AS NOTED ON PLANS REVIEW
CODES ADMINISTRATION
LEE'S SUMMIT, MISSOURI

ISSUE: 1 Addition of JKVRT01 cabinet

DWG: JKVMO-RT01-100
SH 1 OF 3
REV. 3

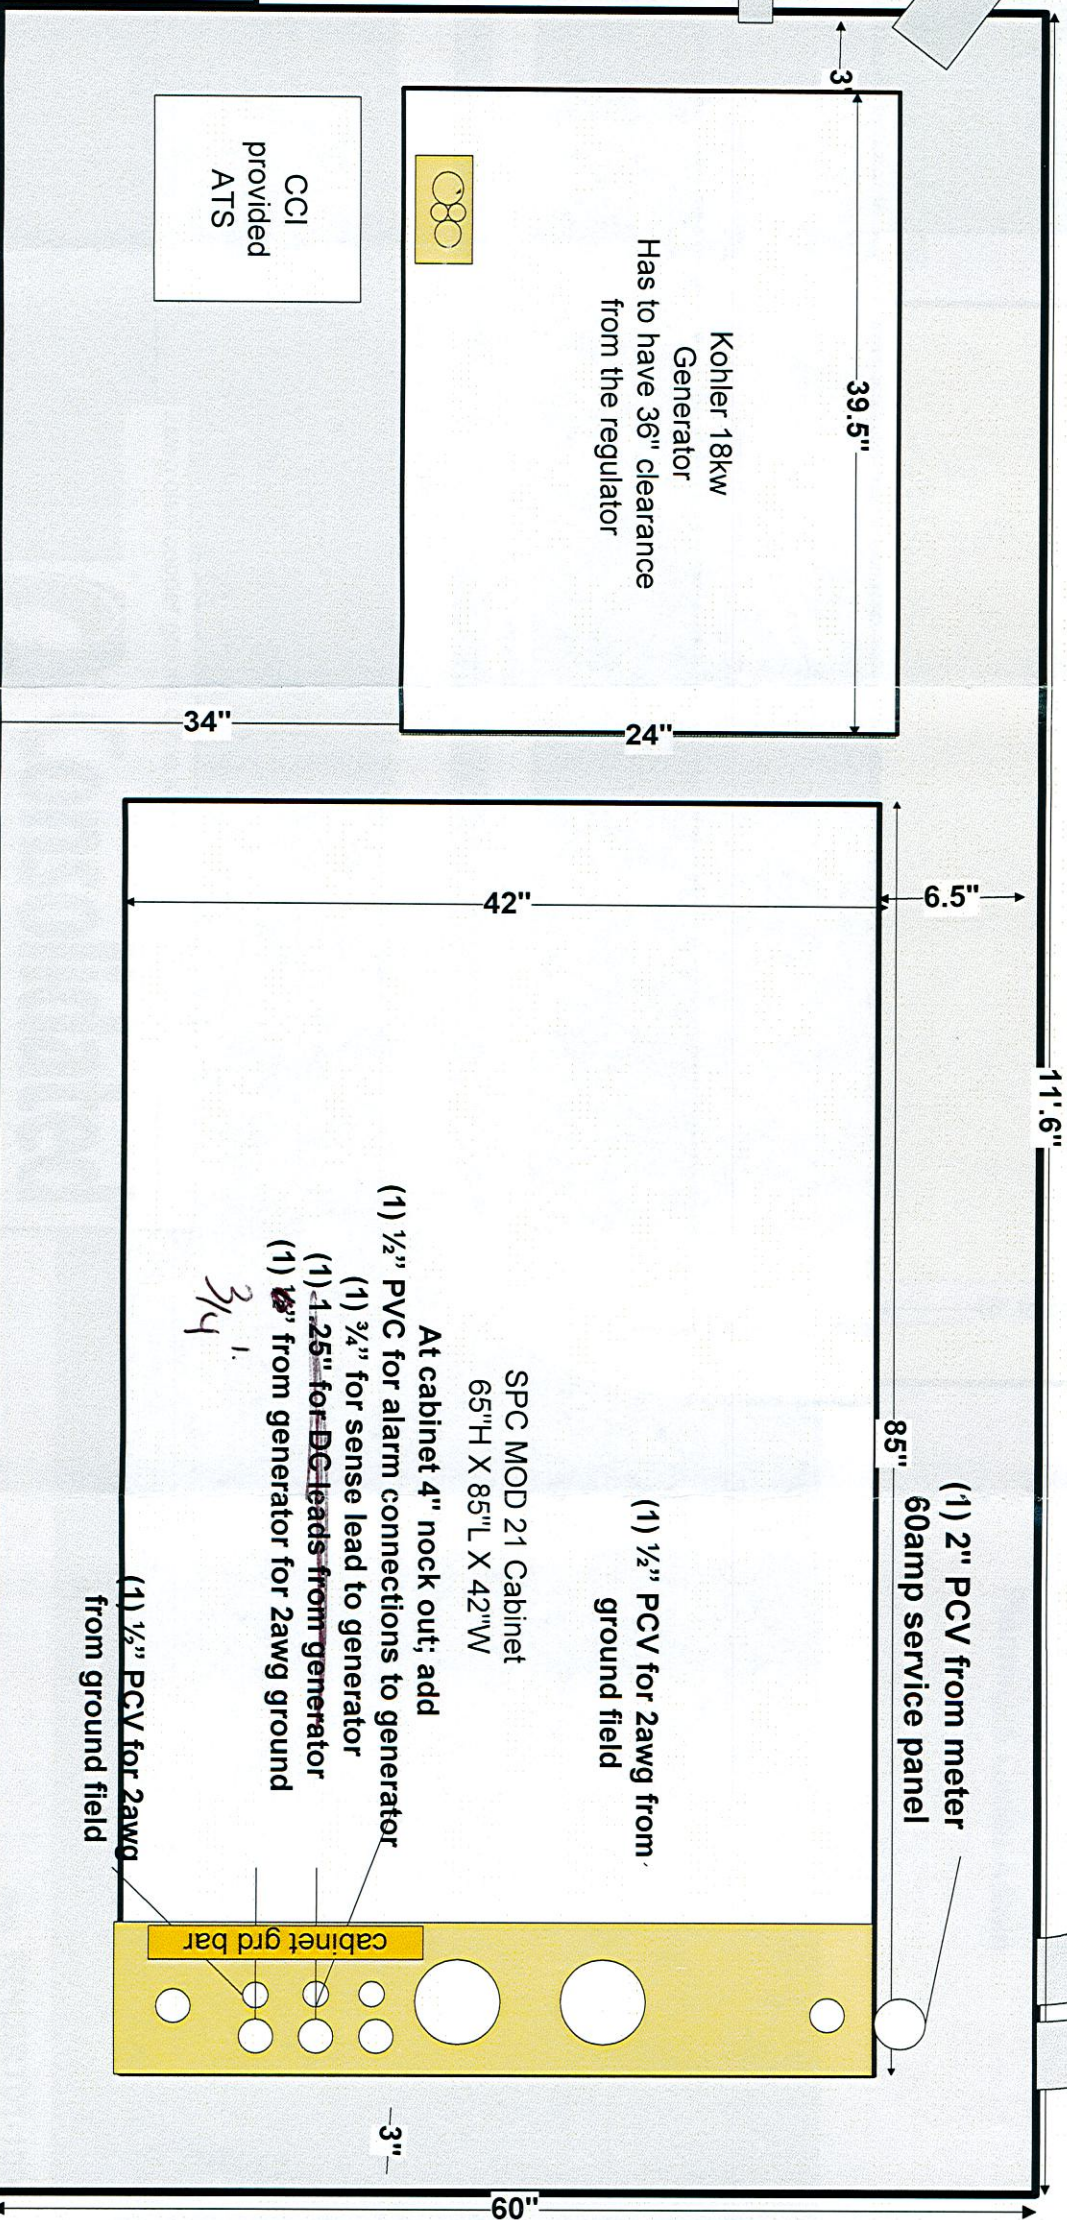
conduit & wire size for Generator / ATS

3/4" Gal - RT for alarms
3/4" Gal - RT for Power Supply / Break Appr
2" ATS - RT cabinet
1" outside eqpt to RT
for grounding
(2) 4" CONDUITS USING 36"
SWEEPS ON ELBOWS
GOING INTO THE CABINET

Locate MH in easement
48" x 48"
36" deep
Add 2" of gravel to manhole

Verify
